CITY OF ROCHESTER, NEW YORK

PORTLAND AVENUE REVITALIZATION

FROM LUX STREET TO NORTON STREET

90% PLANS
APRIL 16, 2014

DRAWING NO.
PL-3
SHEET 16 OF 47
KCI JOB NUMBER
22134062

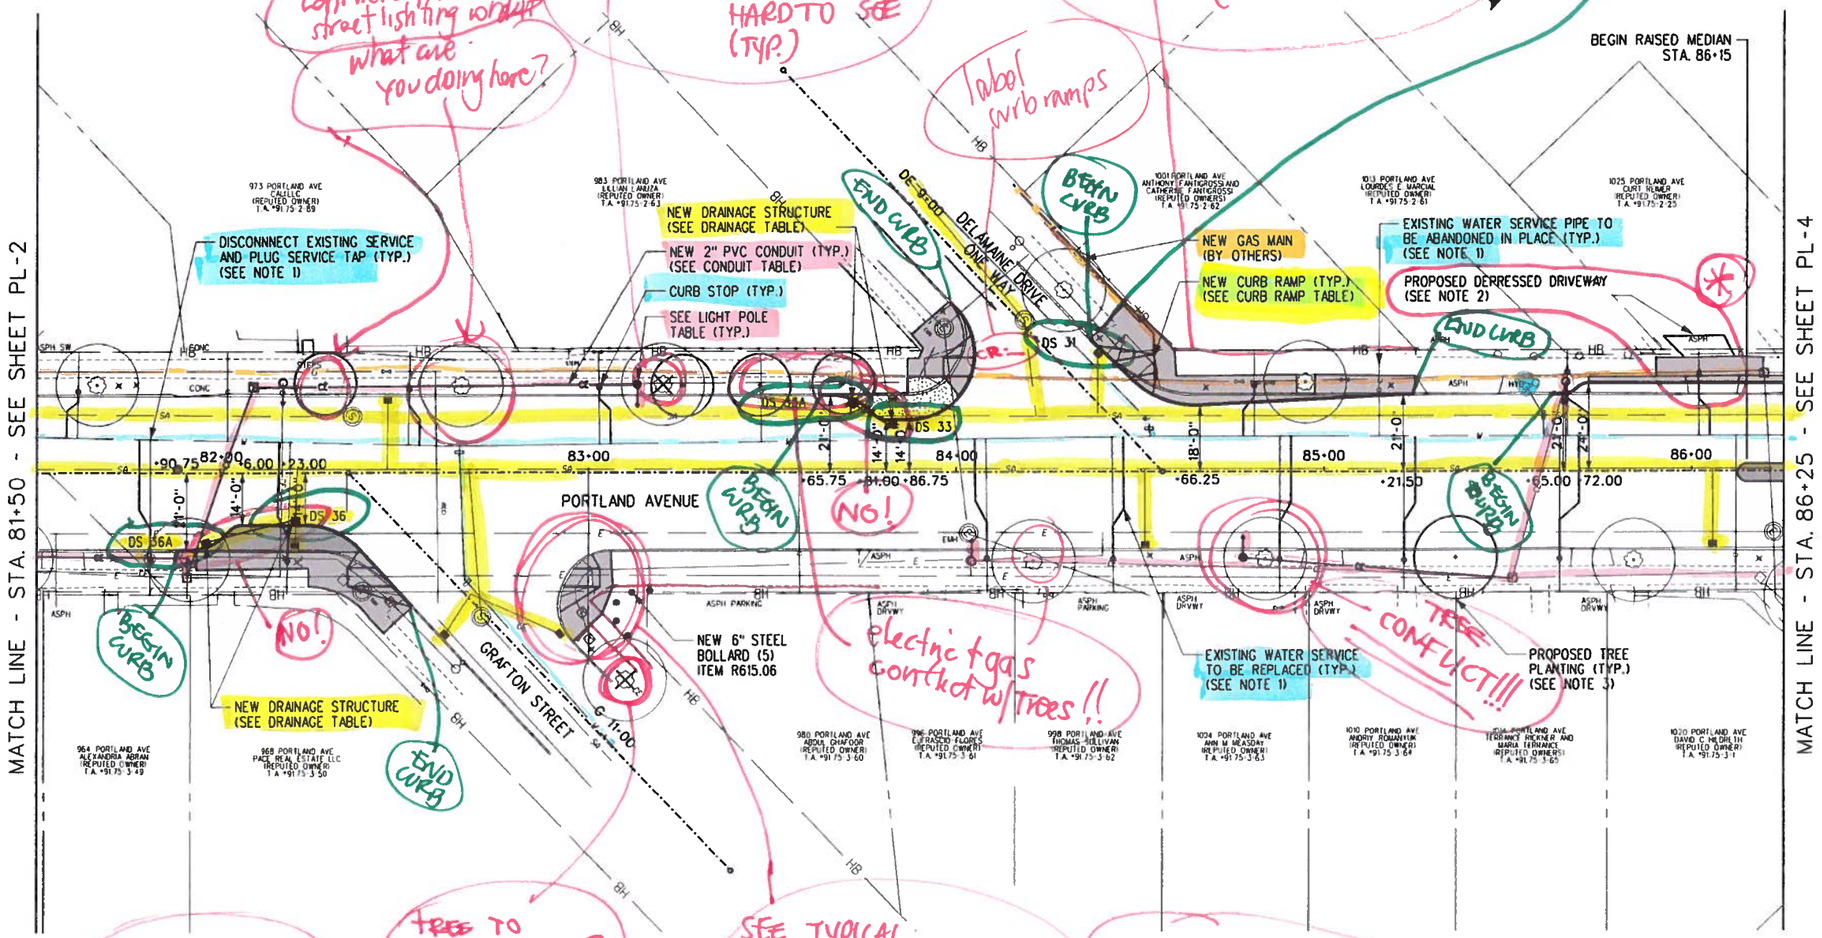
CB/DS #'ing confusing!

Show "X" larger/bolder - hard to see (typ.)

conflict w/new street lighting conduit what are you doing here?

DRAWING NO
PL-6
SHEET 39 OF 47
KCI JOB NUMBER
22134062

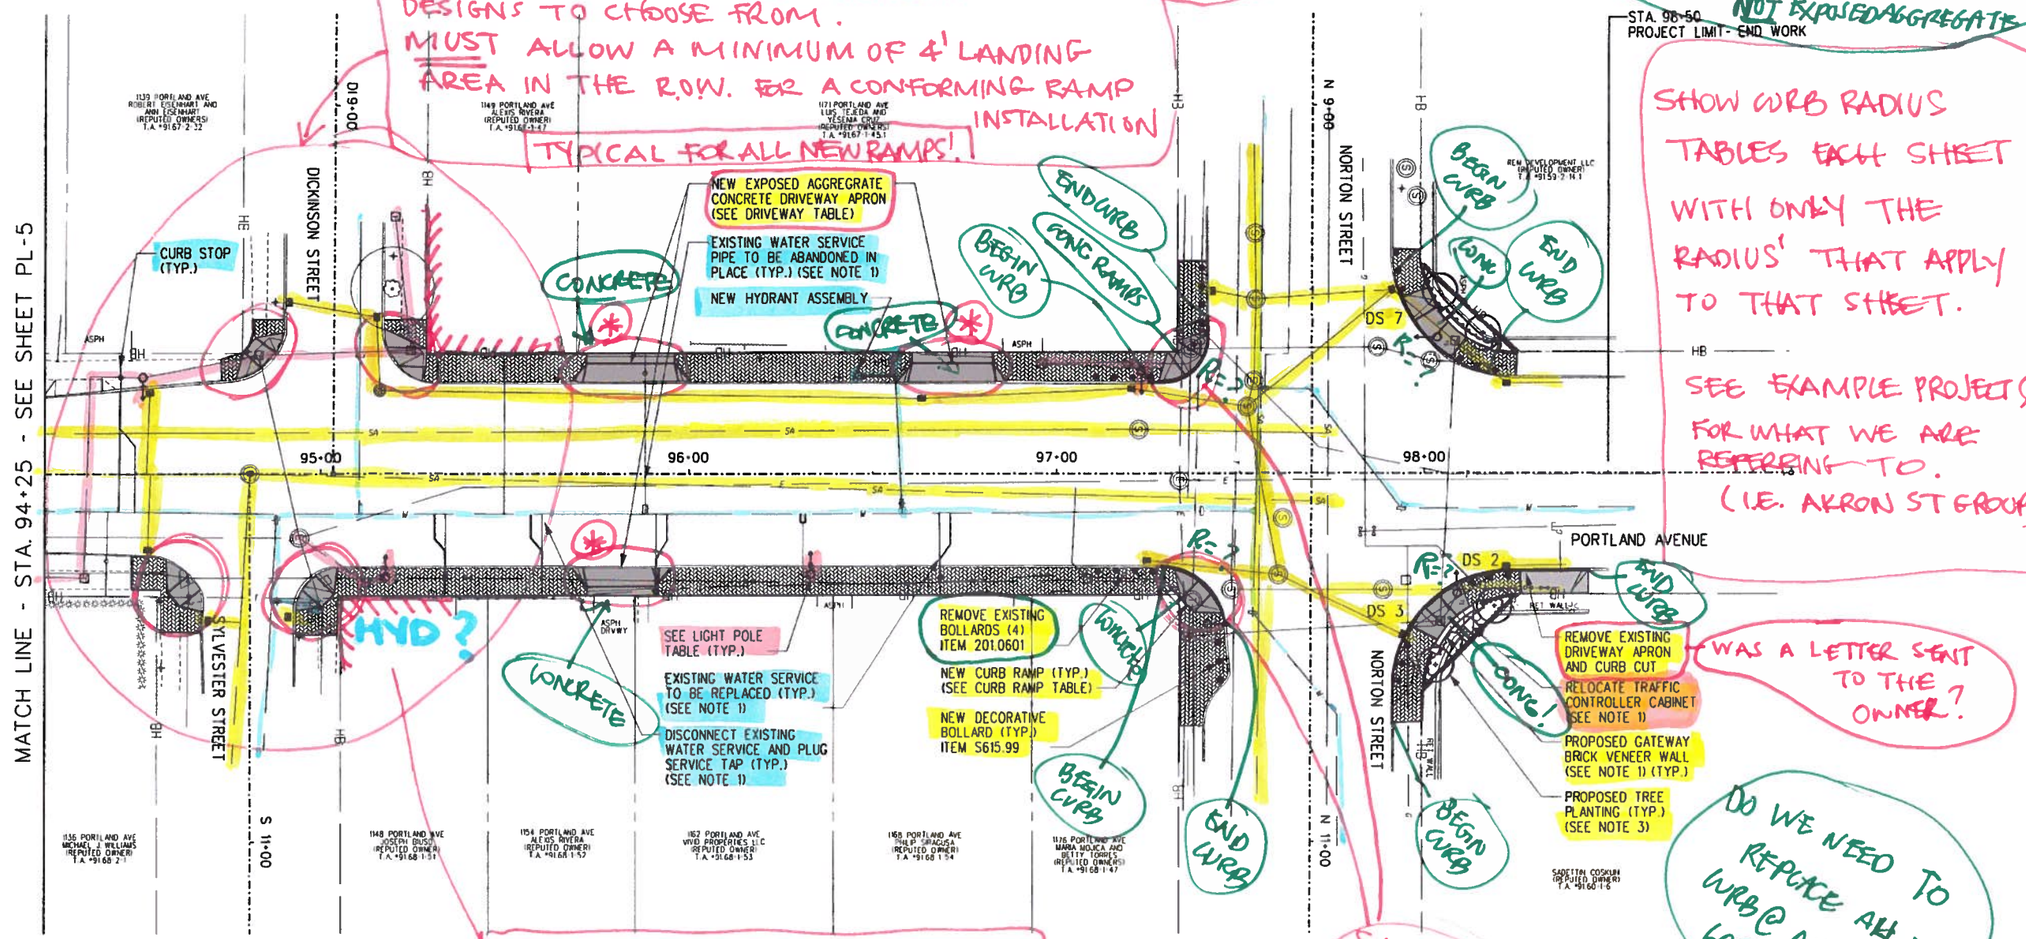
SEE EXAMPLE PROJECTS FOR WHAT WE ARE REFERRING TO. (I.E. AKRON ST GROUP)

DRAWING NO.
PM-1
SHEET 40 OF 47
KCI JOB NUMBER
22134062

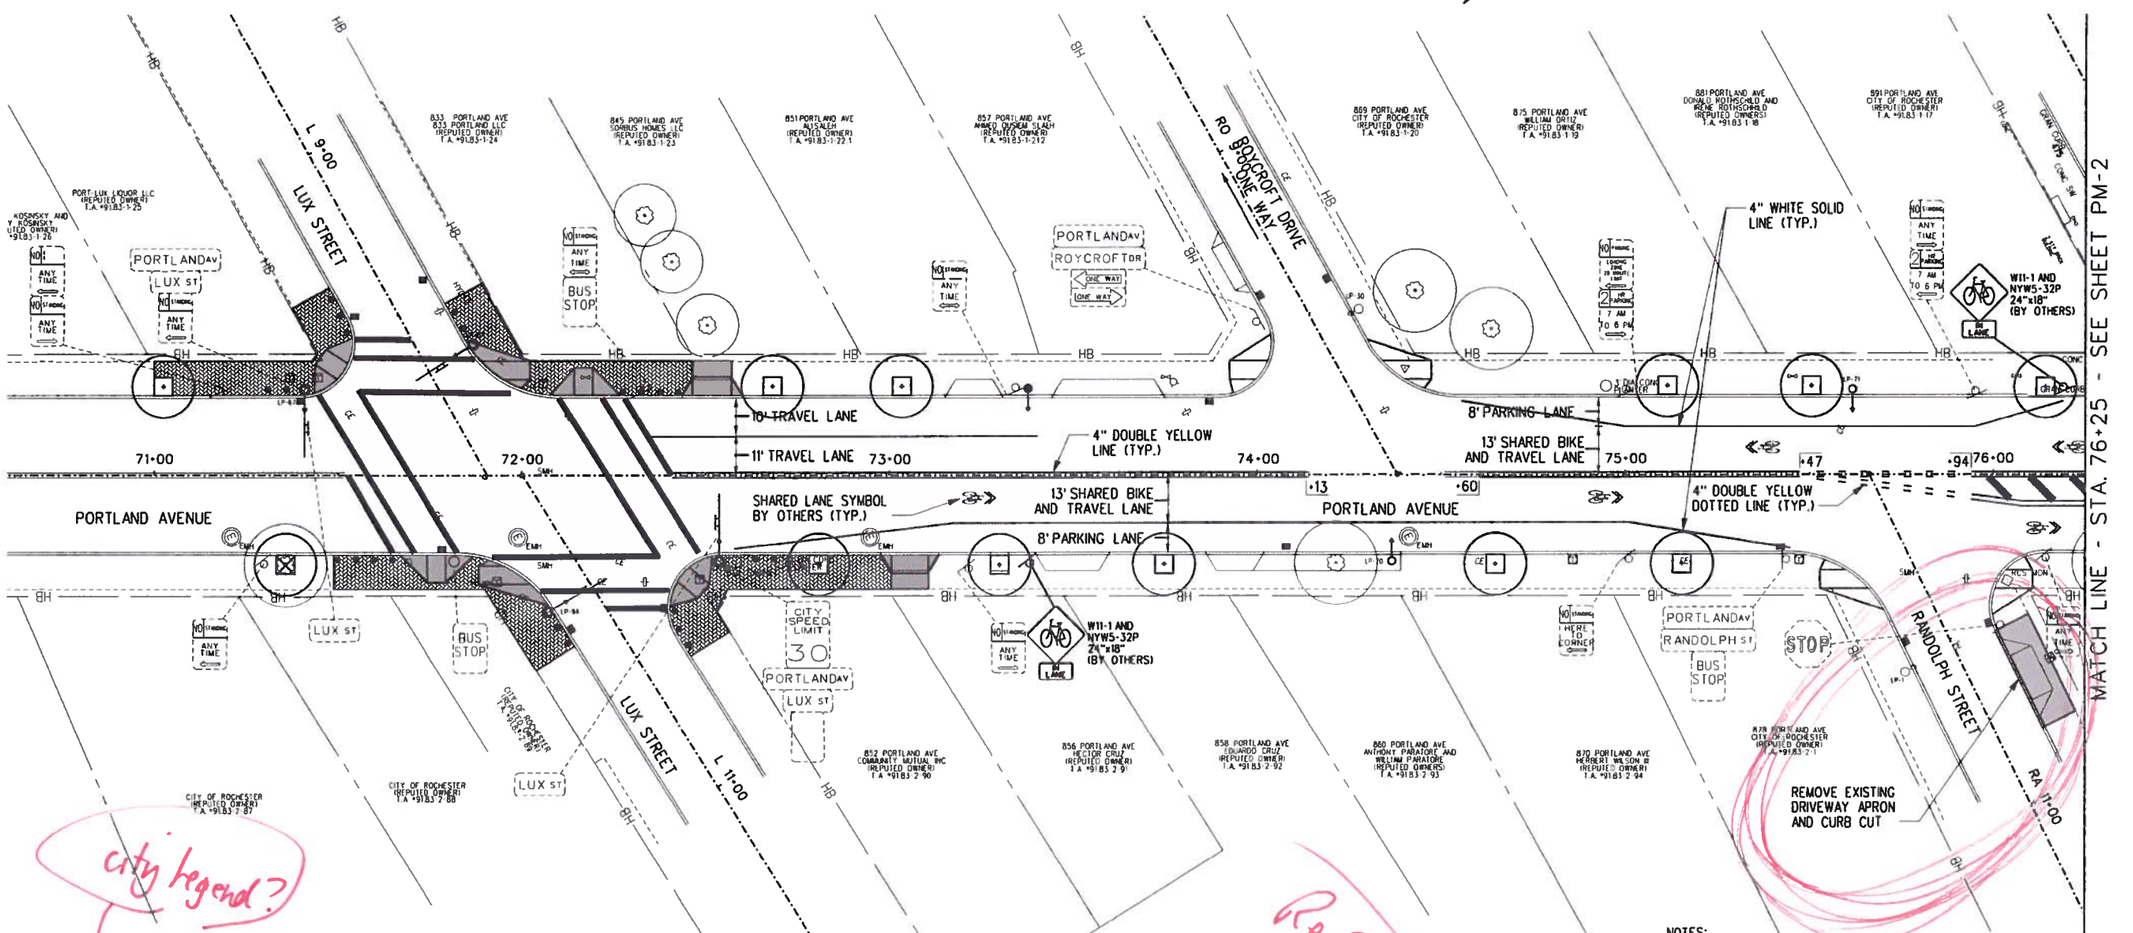
city legend?

DRAWING NO.
PM-2
SHEET 41 OF 47
KCI JOB NUMBER
22134062

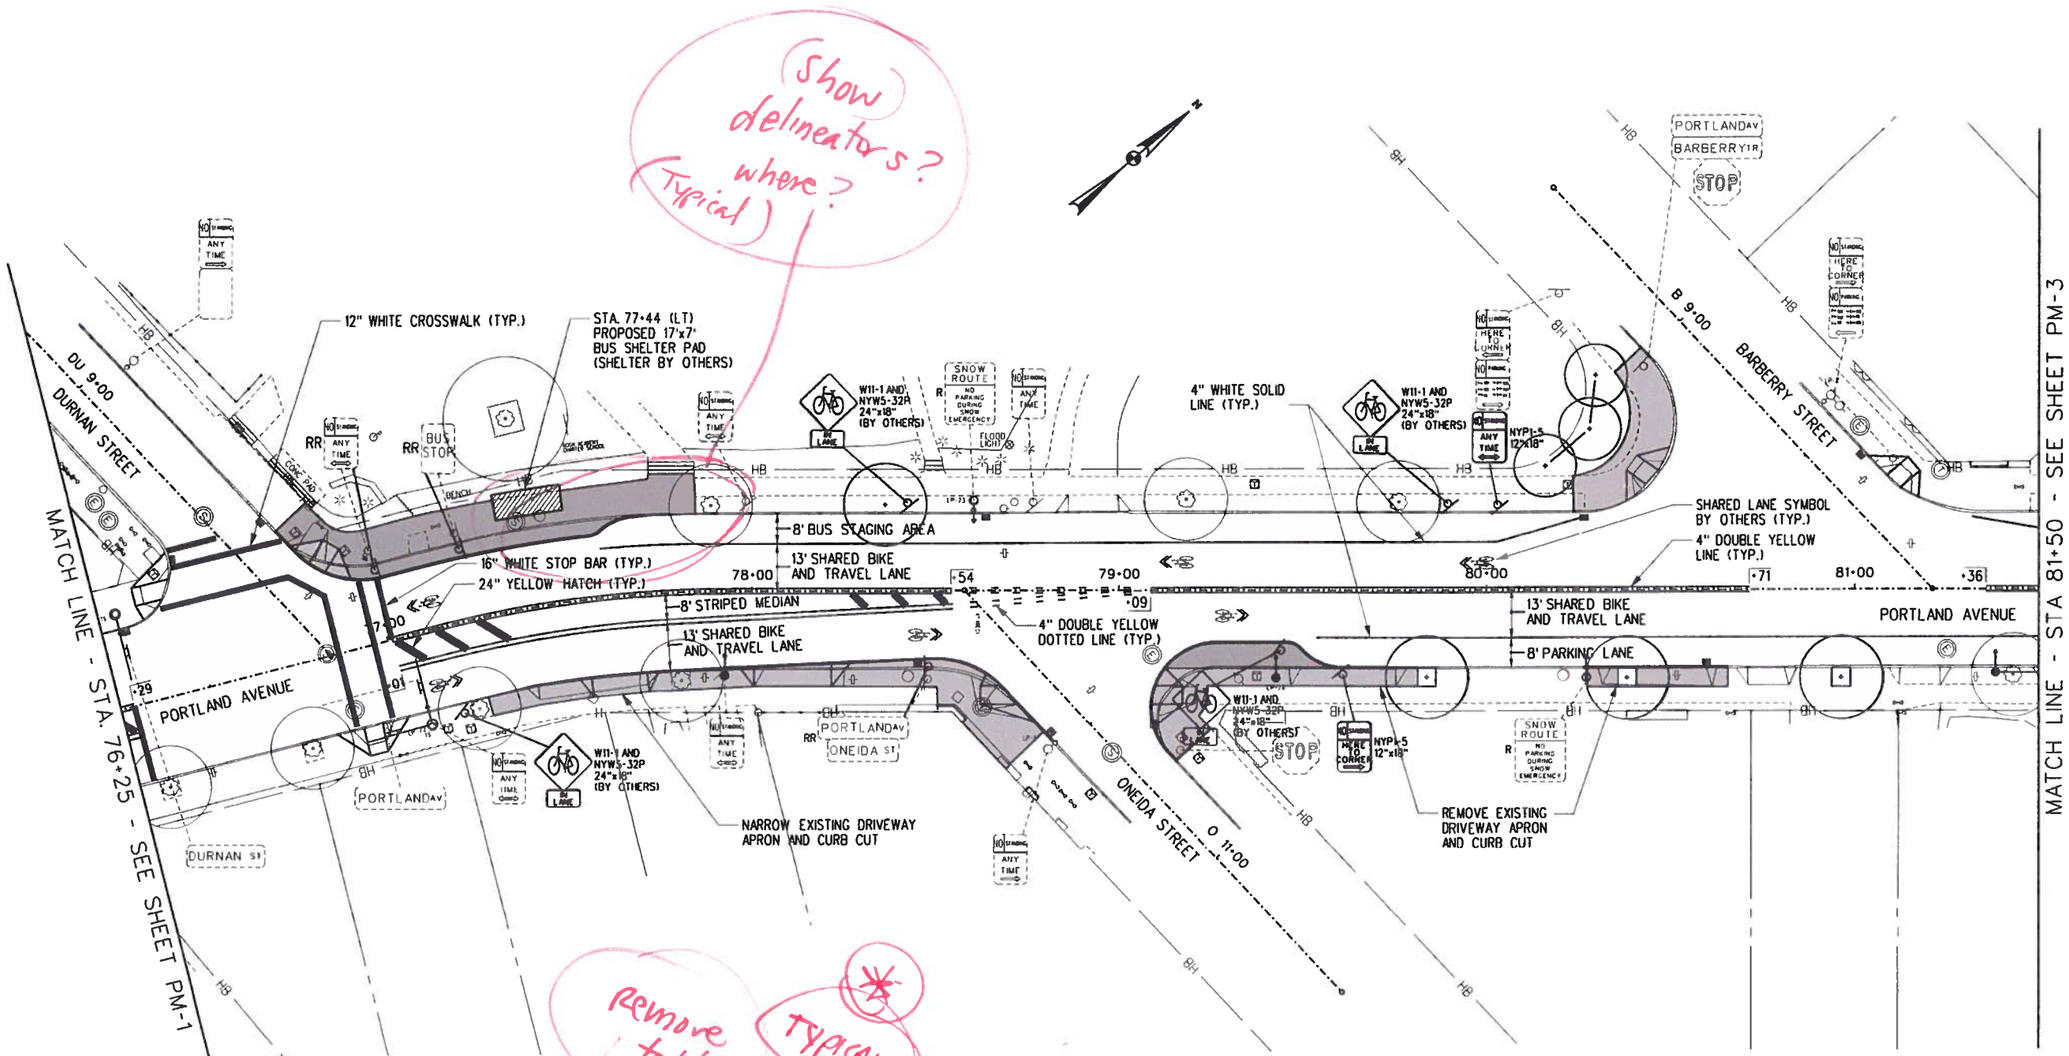
remove to the TYPICAL

show + label on plan with item #

DRAWING NO.
PM-4
SHEET 43 OF 47
KCI JOB NUMBER
22134062

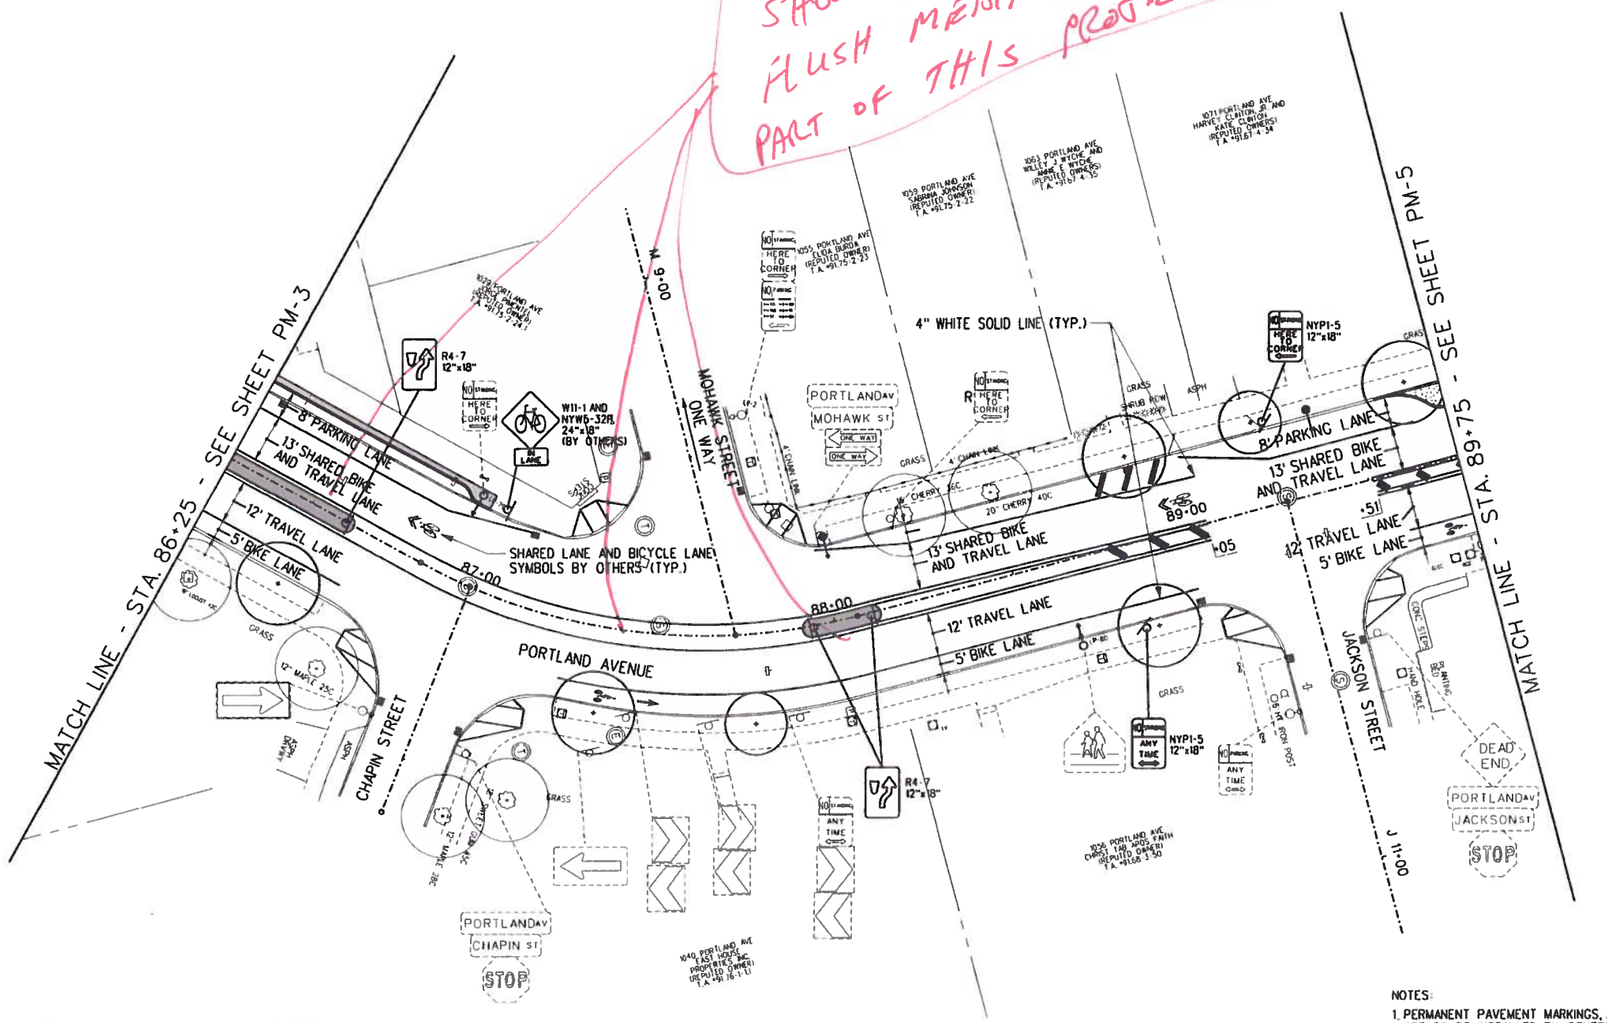
SHOW RAISED & FLUSH MEDIAN AS PART OF THIS PROJECT.

GATEWAY FEATURE WALL (EAST) LOCATION DIAGRAM
NOT TO SCALE

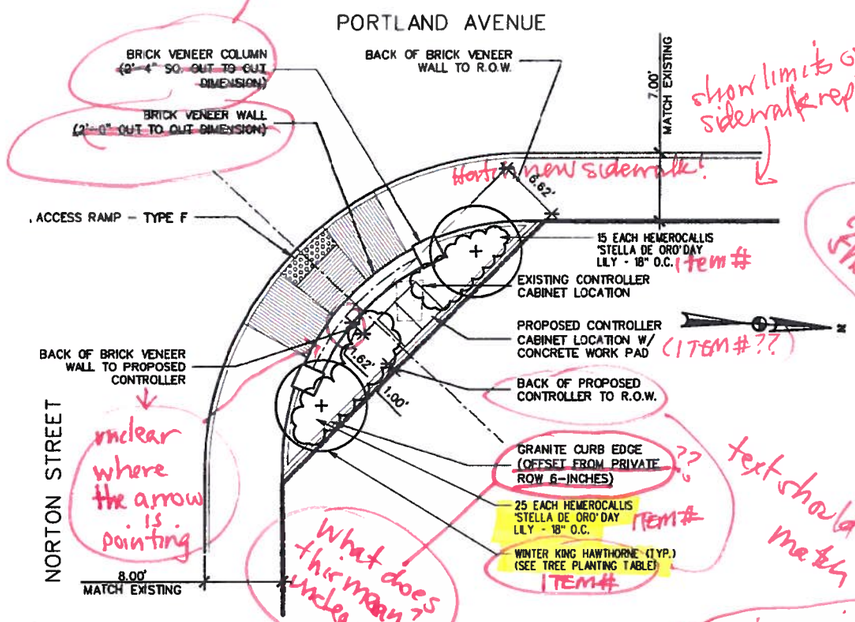
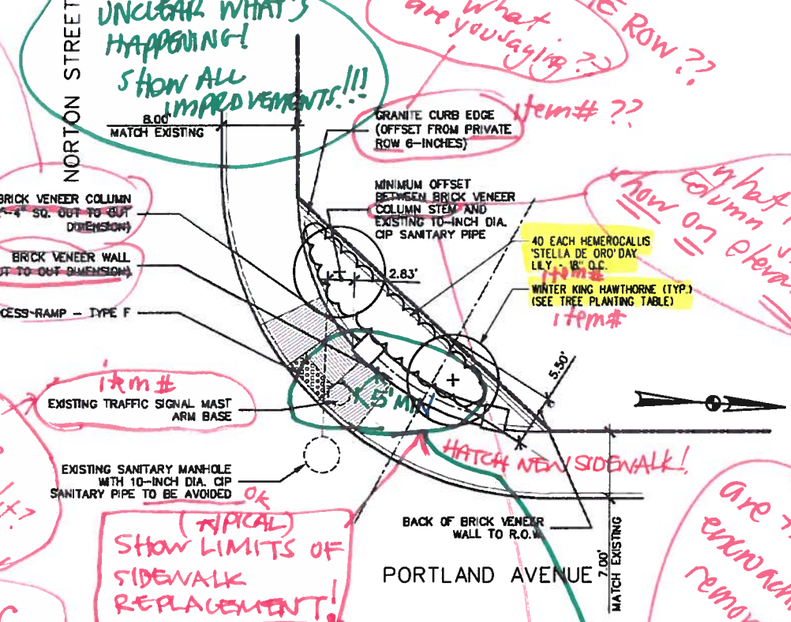
shown on elevation? no need to label dims here.

UNCLEAR WHAT'S HAPPENING! SHOW ALL IMPROVEMENTS!!!

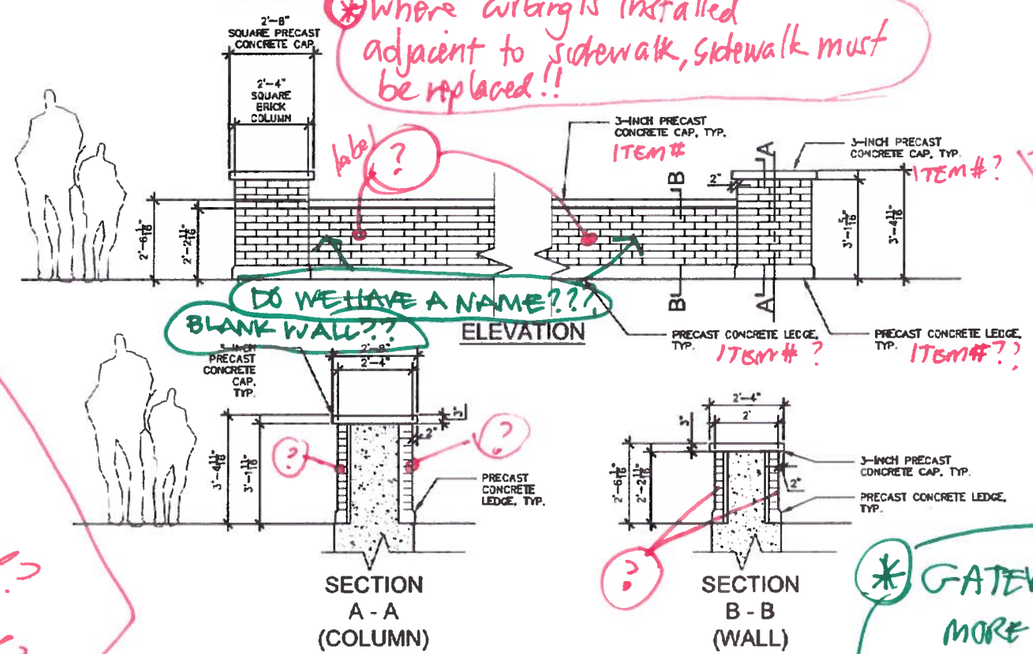
MUST HAVE A MINIMUM 5' CLEARANCE FOR SIDEWALK PLOWS + ADA COMPLIANCE

label?
